SUBJECT: MATERIAL FOR THE SMALL PLANT REVIEW AND APPROVAL FOR THE PRESERVE
AT GOLDFIELD RANCH WATER RECLAMATION FACILITY

Re: The Preserve at Goldfield Ranch Section 208 Review

SRP-MIC
Goldfield Ranch Small Plant Review Technical Support

Figure 1: Potential overland flow path from WRF to Verde River

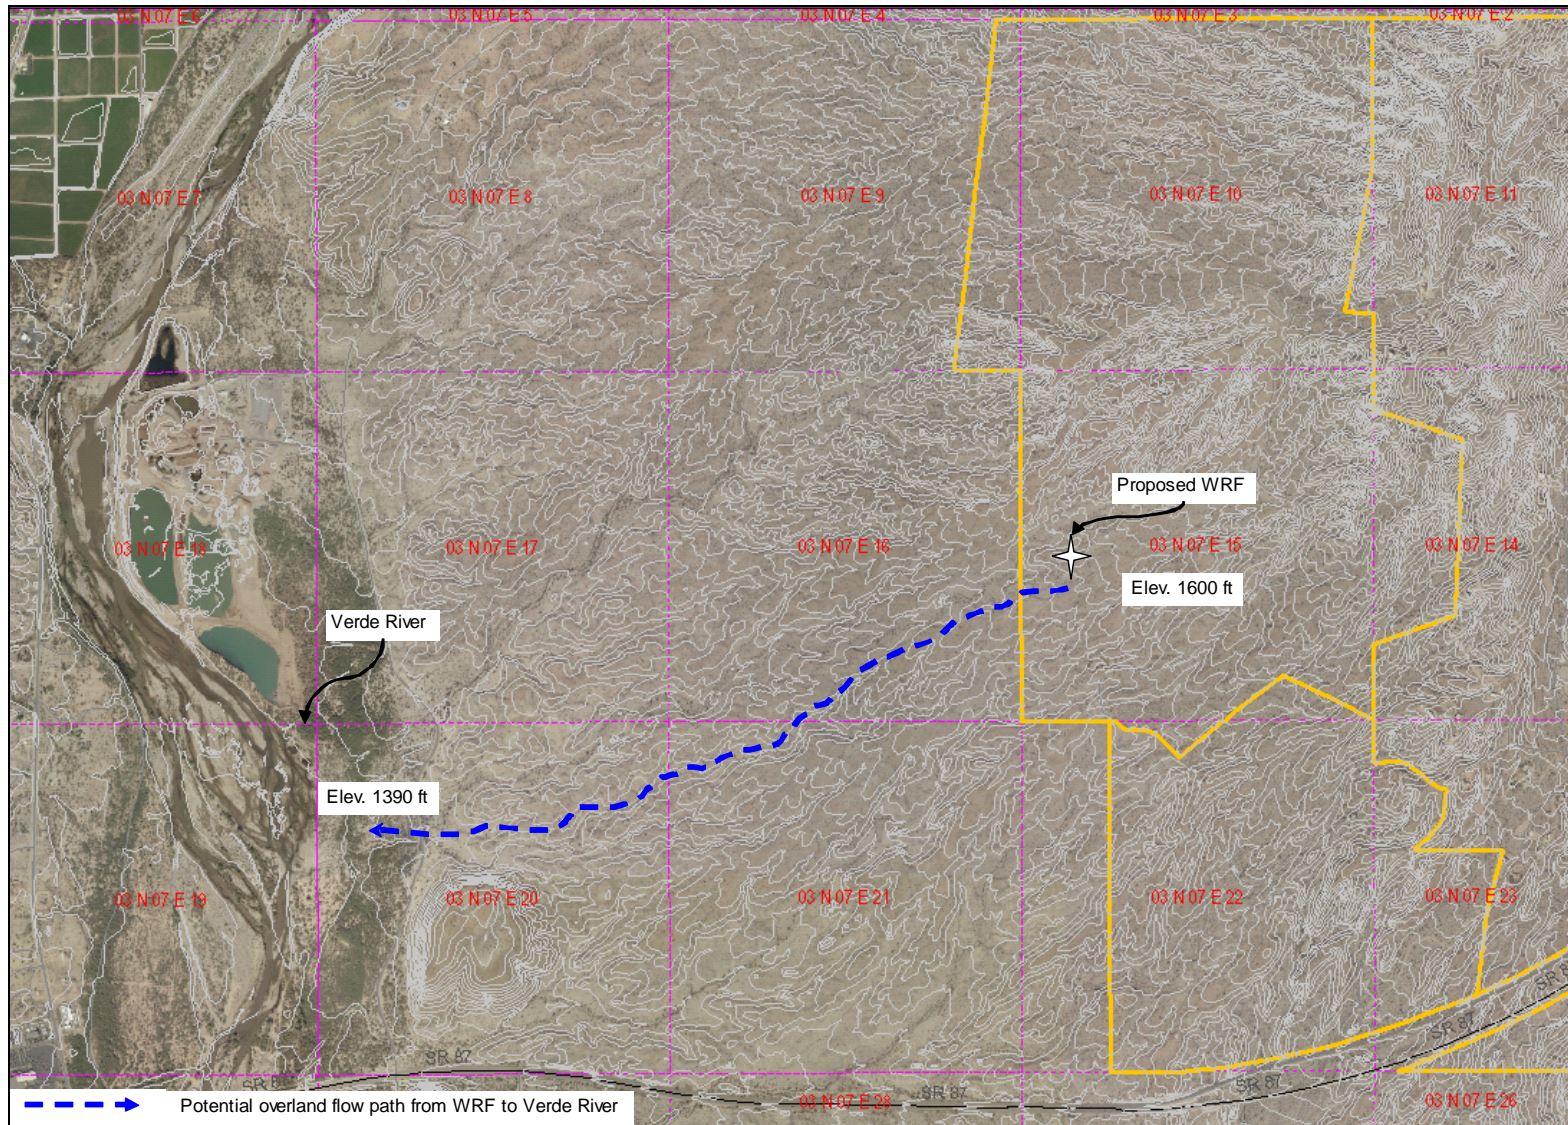
Third, it is located in an area of highly variable land relief near a high-value perennial stream. Plant or conveyance facility failures have a greater potential for rapid flow of raw sewage by gravity to a valuable water body: the Verde River. Overland flow routing calculations estimate that an unimpeded plant failure at full capacity (0.40 MGD) could

The unique features of the proposed plant's location relative to the Verde River, the surrounding topography, and the increased risk it poses to surface water quality standards that have been established for the protection of wildlife and humans have not been adequately considered. While the proposed plant would have redundant power supply and on-site retention, a service failure of it or of the associated sewage lift stations throughout the community (which are not proposed to have redundant power or retention) would result in a sewage overflow that could make its way to the Verde River. The proposed plant location is 2.5 miles from and 210 feet above the Verde River. At build out capacity, unimpeded wastewater overflows from the proposed plant could reach the river within 6 to 18 hours of plant failure.
